**RE: HIGHWAY 427 TRANSPORTATION CORRIDOR DRAFT ENVIRONMENTAL ASSESSMENT
MINISTRY OF TRANSPORTATION
WARDS 1 AND 2**

EXTRACT FROM COUNCIL MEETING MINUTES OF NOVEMBER 24, 2009

11 HIGHWAY 427 TRANSPORTATION CORRIDOR DRAFT ENVIRONMENTAL ASSESSMENT MINISTRY OF TRANSPORTATION WARDS 1 AND 2

Staff has conducted a review of the 427 Transportation Corridor Draft EA Report and has identified the following comments which should be addressed before the EA Report is finalized.

W.O. 05-20012 Highway 427 Transportation Corridor Individual Environmental Assessment	Scale: 1" = 5000' Date: October 2009	RECOMMENDED PLAN STA. 15+250 TO STA. 16+638.056	EXHIBIT 6-3 (Plate 4)

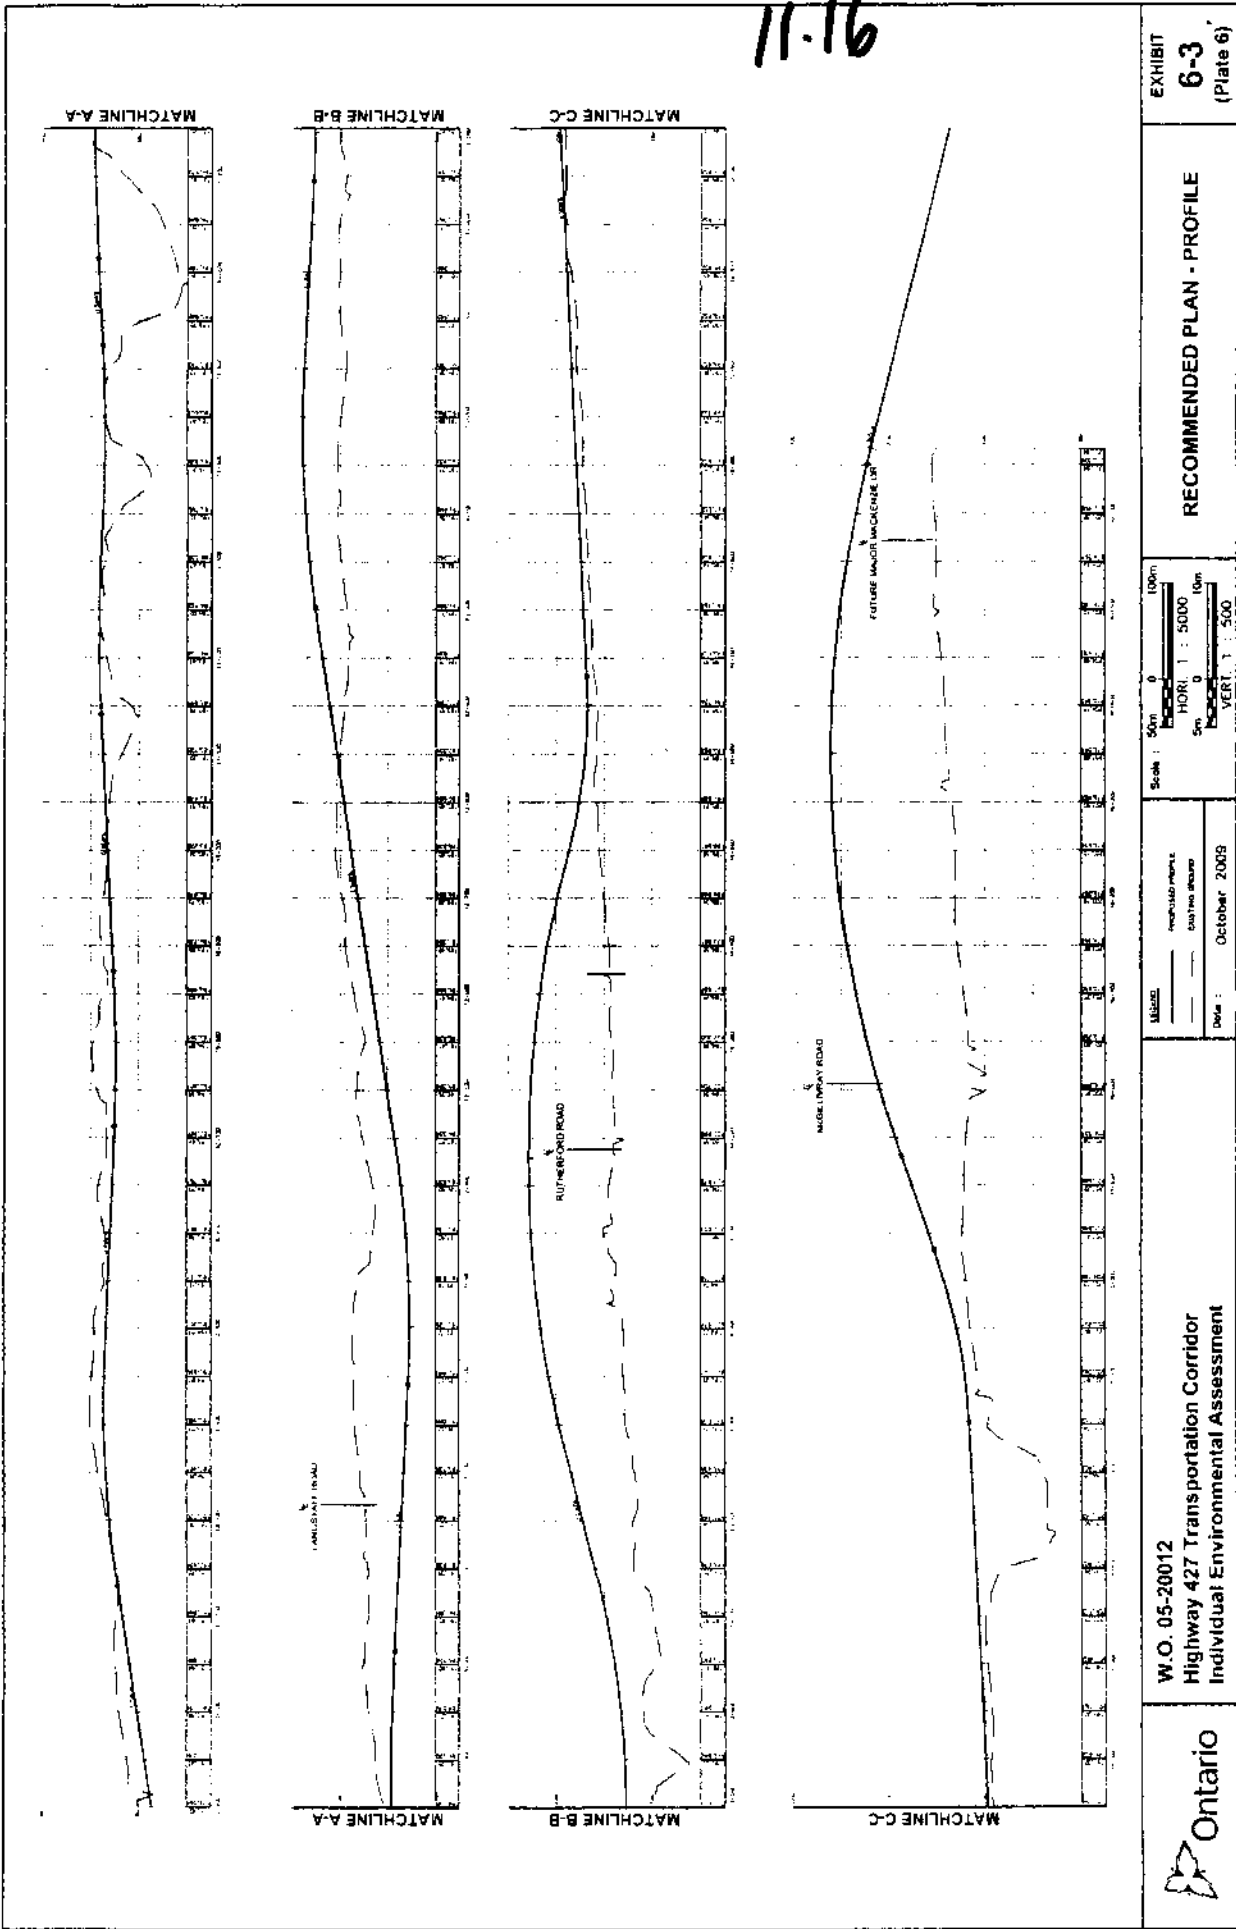
5. As recommended in the 427 EA, Huntington Road south of Major Mackenzie Drive will be realigned to connect to McGillivray Road. In addition, an interim access is proposed to connect McGillivray Road to Major Mackenzie as identified on Attachment No. 4 (Exhibit 6.3, Plate 4). It is important to note that in 2004, the City completed a Class Environmental Assessment that assessed the opportunities to improve operations for both vehicles and train traffic at the Huntington Road crossing. Increased demand for intermodal transportation results in a greater volume of trains accessing the terminal, periodically blocking Huntington Road at the rail crossing. The City's EA recommended the establishment of a temporary road link between McGillivray Road and Major Mackenzie Drive at a location approximately 700m east of the existing Huntington Road alignment. This new road link was proposed to be in place for approximately 5-8 years until the Highway 427 extension was selected and a longer term transportation solution for this area could be considered.

The City in their consultation with the MTO and correspondence of June 2, 2009, requested that as part of the 427 EA Study, MTO investigate the feasibility of making a permanent connection from McGillivray Road to Major Mackenzie Drive. Options evaluated in the City's Huntington Road Class EA could be utilized in determining the appropriate location of this road link which provides adequate spacing between the future interchange and CP Rail line. In addition, this new roadway should be coordinated with

the future access to the Nashville Community Plan on the north side of Major Mackenzie Drive. A connection to Major Mackenzie Drive is necessary to accommodate the proposed employment area south of Major Mackenzie Drive, north of Rutherford Road, east of the future Highway 427 and west of the CP Rail line. The extension of Highway 427 and the existing CP Rail line prohibit any additional east-west access opportunities to these lands in addition to the proposed McGillivray Road crossing under the future Highway 427 extension.

Therefore, it is paramount that the final 427 EA study identify the intersection location of a future permanent roadway on the south side of Major Mackenzie Drive to serve the West Vaughan Enterprise Zone lands and north of Major Mackenzie Drive to serve the Nashville West Community.

7. Additional clarification should be provided on the McGillivray Road cross-section under the proposed Highway 427 Overpass structure at CPR/McGillivray Road as shown on Attachment No.4 (Exhibit 6-3, Plate 4). The City does not currently have any plans to widen McGillivray Road; however, as indicated in our previous comments, lands south of Major Mackenzie Drive have been designated for the future employment use. The City will be preparing a secondary plan for these lands as part of the City-Wide Official Plan process and it is anticipated that McGillivray Road will need to be widened some time in the future in order to accommodate development of the future employment lands. **The proposed Highway 427 Overpass structure at CPR/McGillivray Road should accommodate the future expansion of McGillivray Road to provide for four lanes of traffic, and 1.5 meter sidewalk on both sides of the road.**

6 LANE SECTION HIGHWAY 7 TO RUTHERFORD ROAD

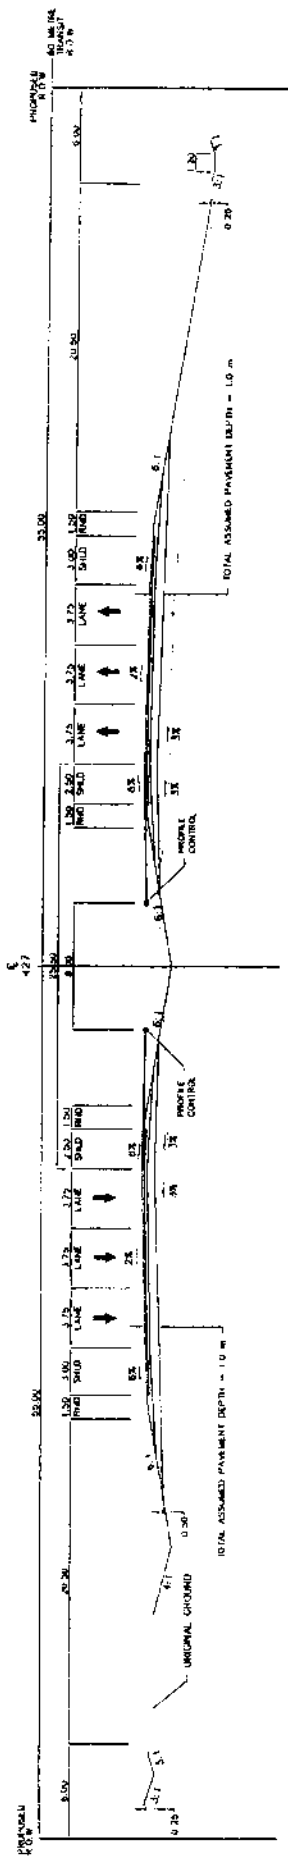
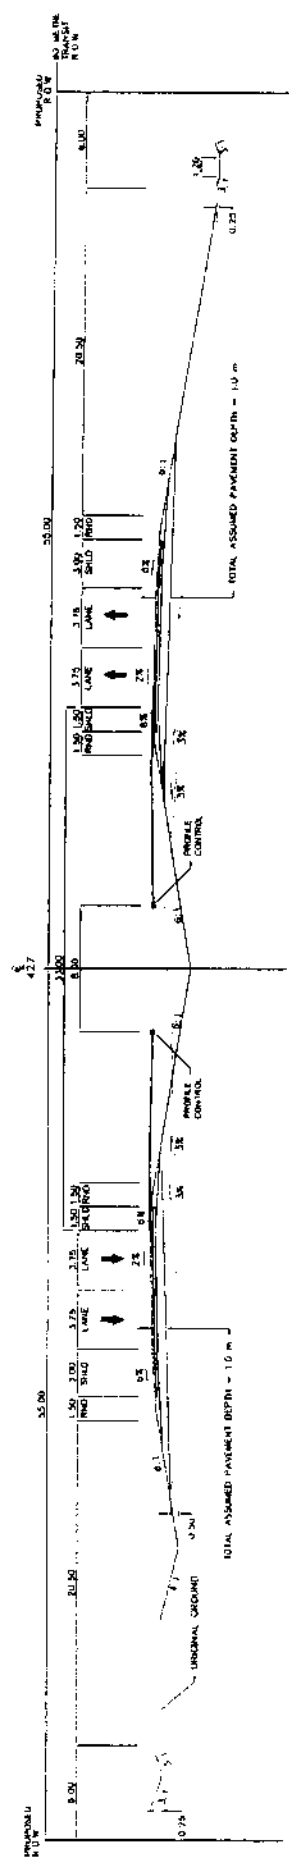
2. The relevant pedestrian and cycling facilities that are identified in both the City of Vaughan and Region of York Pedestrian and Bicycle Master Plans should be referenced in the EA Report and reflected on the appropriate highway plan and cross-section drawings. **Sidewalks and illumination will be required on all of the proposed highway crossings including Zenway Boulevard, Langstaff Road, Rutherford Road, McGillivray Road and Major Mackenzie Drive.**
